Access Compliance Report

Public Rights-of-Way

Intersection ID: 6063	Main Street: ALPINE_LN	Cross Street: HOOVER_DR	Location: NW
ADA ID: DA55AE557FB5	Ramp Type: BlendTrans1	Initial Pass/Fail: Pass	Overall Compliance: No
		Severity Score: 0

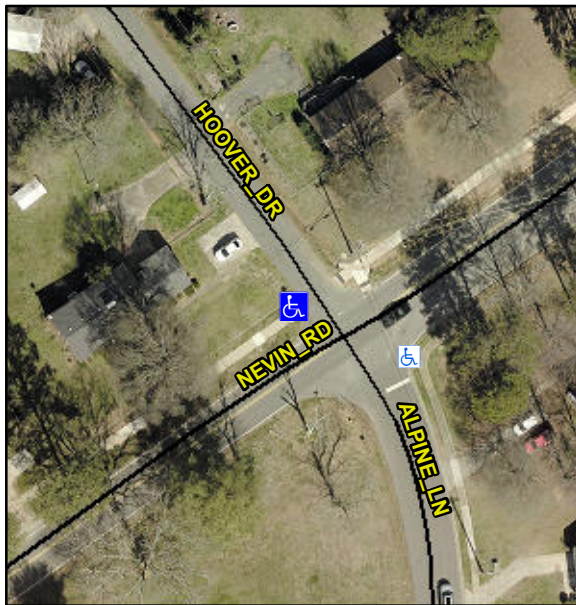
NO CURB

R304.2.2-Perp, R304.3.2-Para, R305.2

Remove & Replace Curb Ramp With Two New Directional Ramps or Equivalent.
